Reference: Beaver Valley Power Station, Unit No. 1
Docket No. 50-334, License No. DPR-66
Post Implementation Review of NUREG-0737, Items
II.F.1.4, II.F.1.5 and II.F.1.6

Beaver Valley Power Station
Unit No. 1

Response to NRC Letter
dated December 16, 1982

CONTAINMENT HYDROGEN ANALYZER SYSTEM
FIGURE 3

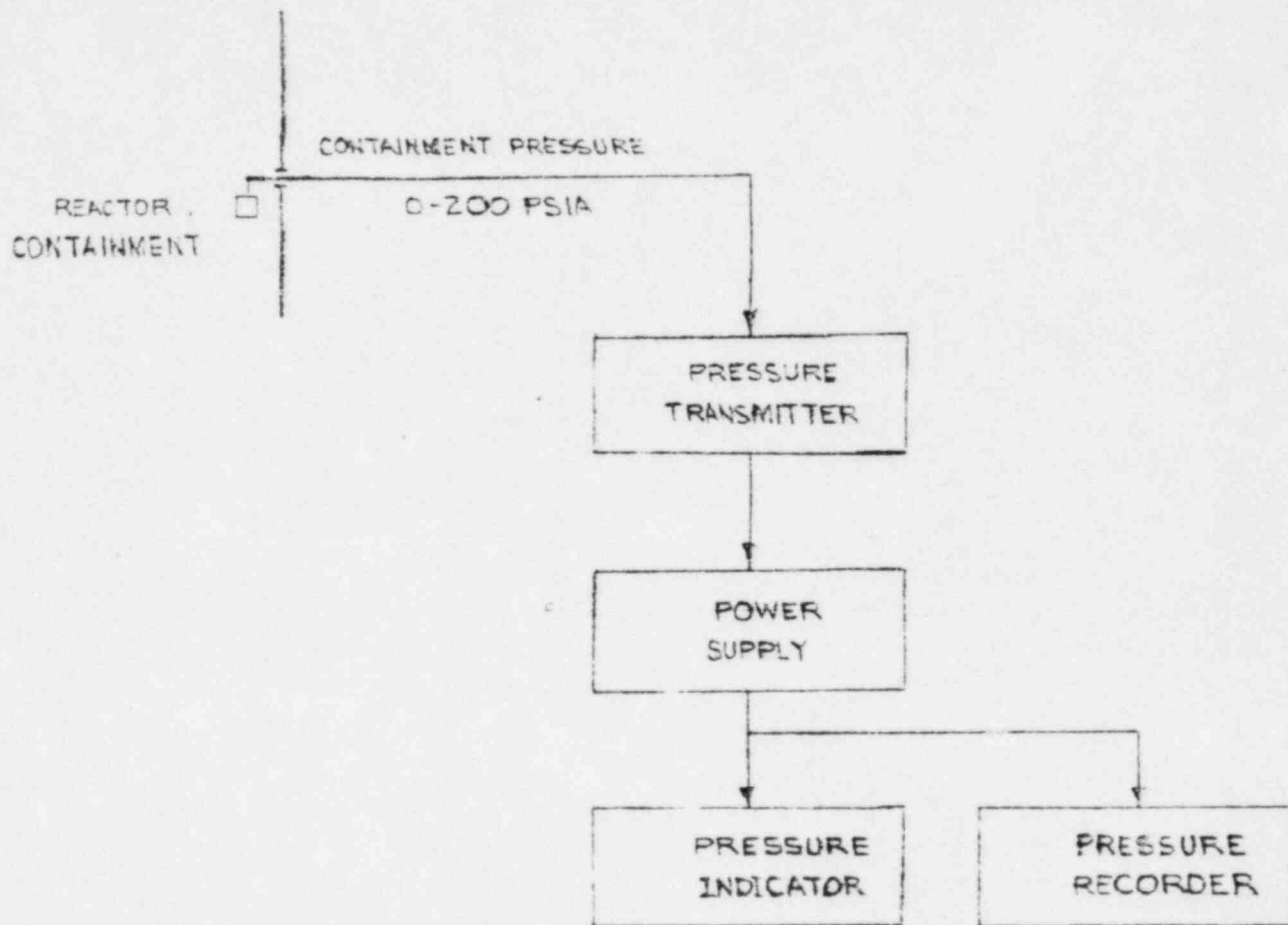
- 4a. Provide a block diagram of the configuration of modules that make up your HMS. Provide an explanation of any details in the block diagram that might be necessary for an understanding of your HMS accuracy. If you have different types of HMSs, give this information for each type.

- Refer to Figure 3 for a block diagram and for equipment location relative to containment
 - Refer to the Response to 4c
- 4b. For each module provide a list of all parameters which describe the overall uncertainty in the transfer function of that module.

The hydrogen analyzer determines hydrogen content in a gas sample by passing the sample gas and a reference gas across the two sides of a heated thermal conductivity cell. The difference in thermal conductivity of the two gases generates a signal which is displayed in the control room. Since the gas sample contains water vapor plus hydrogen, the indicated reading will be higher than the actual hydrogen concentration due to the thermal conductivity contribution of the water vapor in the sample. This indication may be corrected by determining the water vapor contribution and subtracting this from the indicated reading. The greatest difference in indicated hydrogen concentration versus actual concentration has been calculated to be 1.9%, thus an indicated reading of 4% hydrogen concentration would correspond to an actual concentration of 2.1% hydrogen. The PMS uncertainty and the analyzer ambient temperature monitoring system uncertainty have been included in the determination of the overall HMS uncertainty.

The hydrogen analyzer can sample the containment atmosphere in two locations, the dome region of the containment or the pressurizer cubicle within containment. Each location has two intake ports. Either sample location may be selected from the control room by selectively opening or closing the appropriate containment isolation valves.

FIGURE 1

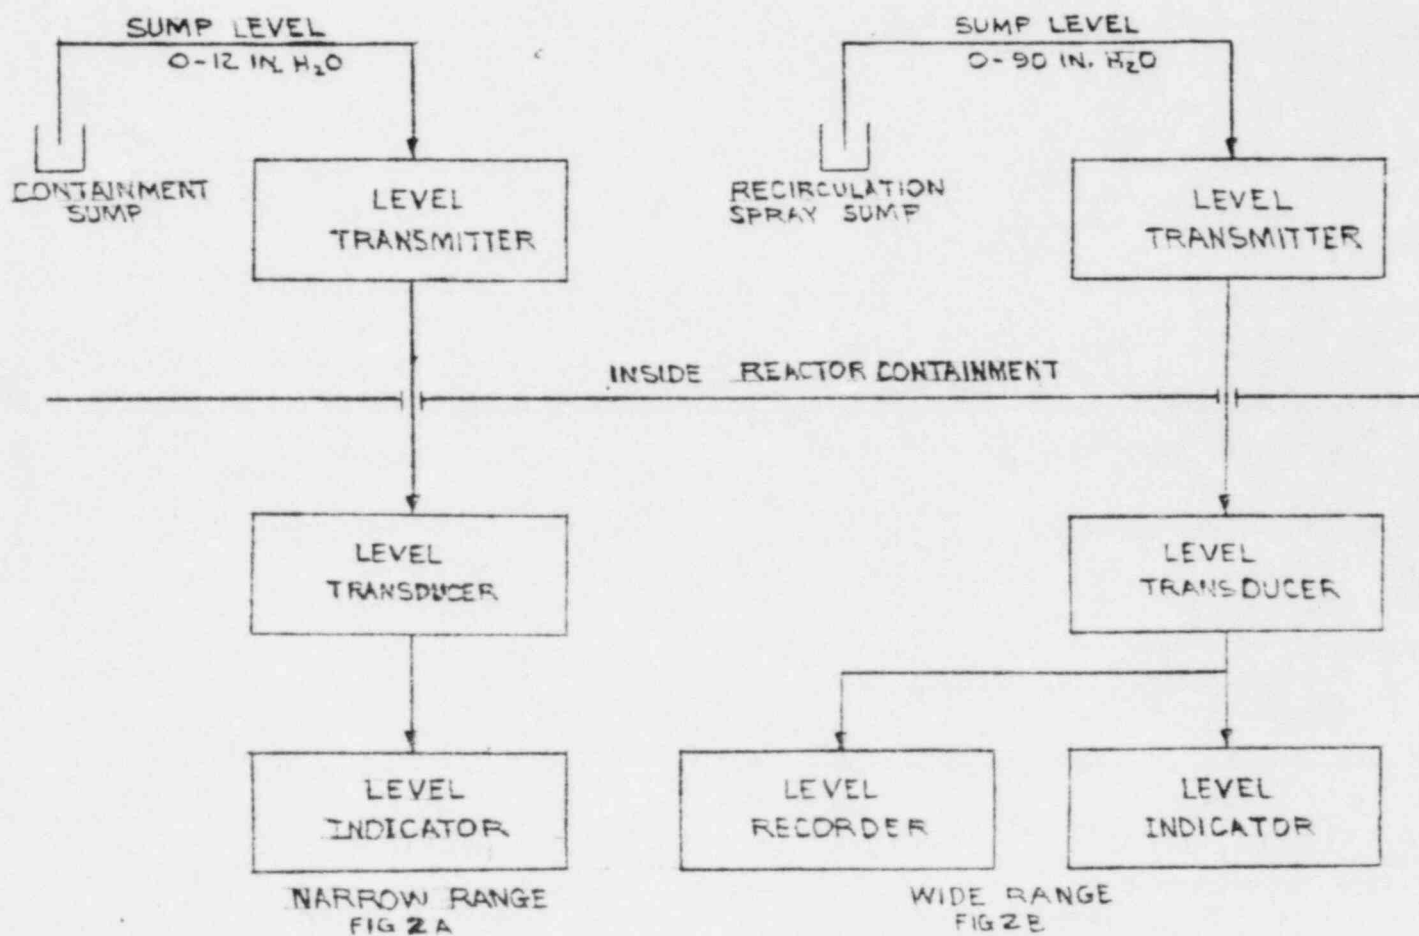
- 2a. Provide a block diagram of the configuration of modules that make up your PMS. Provide an explanation of any details in the block diagram that might be necessary for an understanding of your PMS accuracy and time response.

Refer to Figure 1 for a block diagram and equipment location relative to containment.

Pressure Transmitter

Range:	0-200 psia
Accuracy:	$\pm 0.25\%$ (Full Scale)
Temperature Effect:	$\pm 3.75\%$ per 100° (65° - 116° F)
Stability:	$\pm 0.375\%$ in six months

Reducing each of the error parameters in 2b to one standard deviation and then combining the reduced parameters using the Root-Sum-Square method, results in overall system uncertainties as follows:

PMS Indication:	$\pm 0.897\%$ (Full Scale)
PMS Recording:	$\pm 0.763\%$ (Full Scale)

FIGURE 2

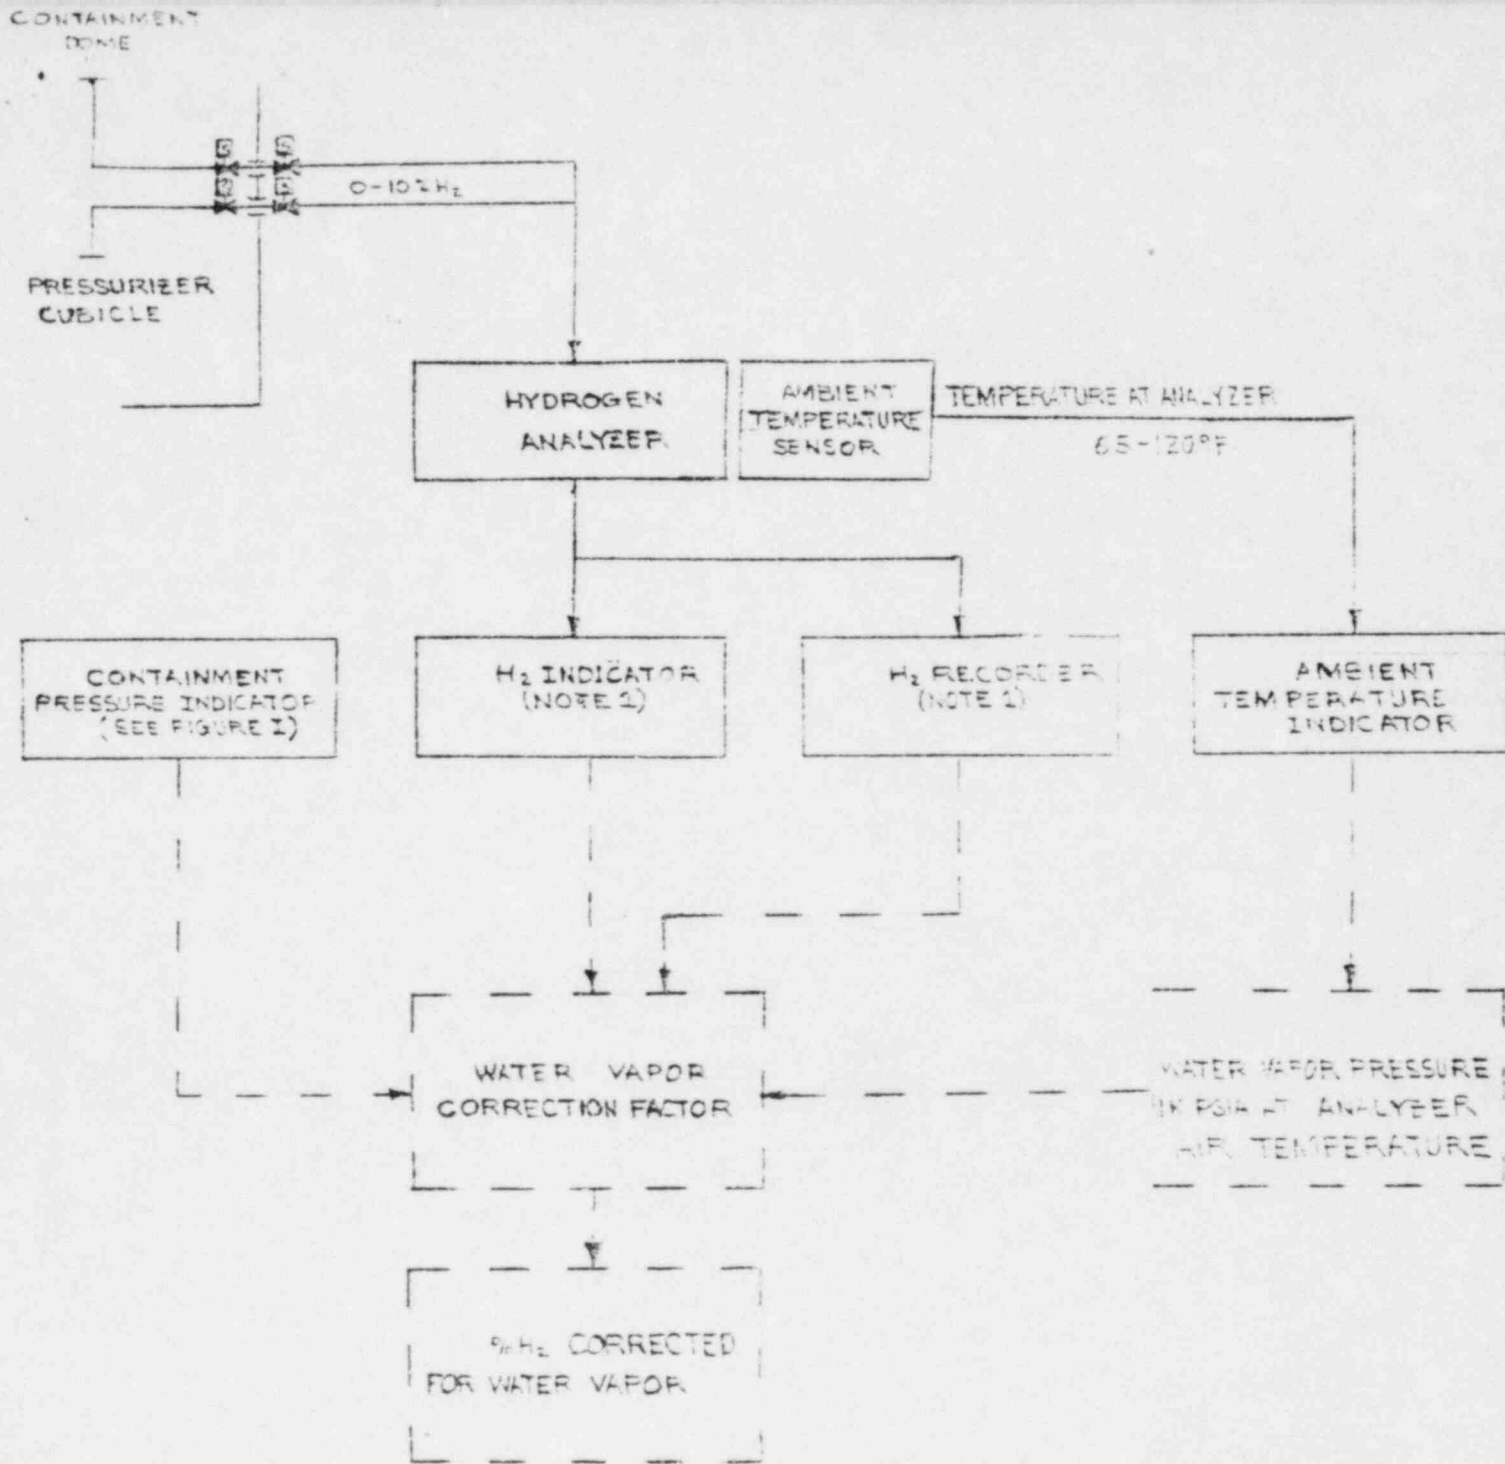
- 3a. Provide a block diagram of the configuration of modules that make up your WLMS. Provide an explanation of any details in the block diagram that might be necessary for an understanding of your WLMS accuracy.

Refer to Figure 2 for a block diagram and for equipment location relative to containment.

Reducing each of the error parameters in 3b to one standard deviation and then combining the reduced parameters using the Root-Sum-Square method, results in overall system uncertainties as follows:

WLMS Wide Range Indication:	$\pm 0.85\%$ (Full Scale)
WLMS Wide Range Recording:	$\pm 0.71\%$ (Full Scale)
WLMS Narrow Range Indication:	$\pm 1.62\%$ (Full Scale)
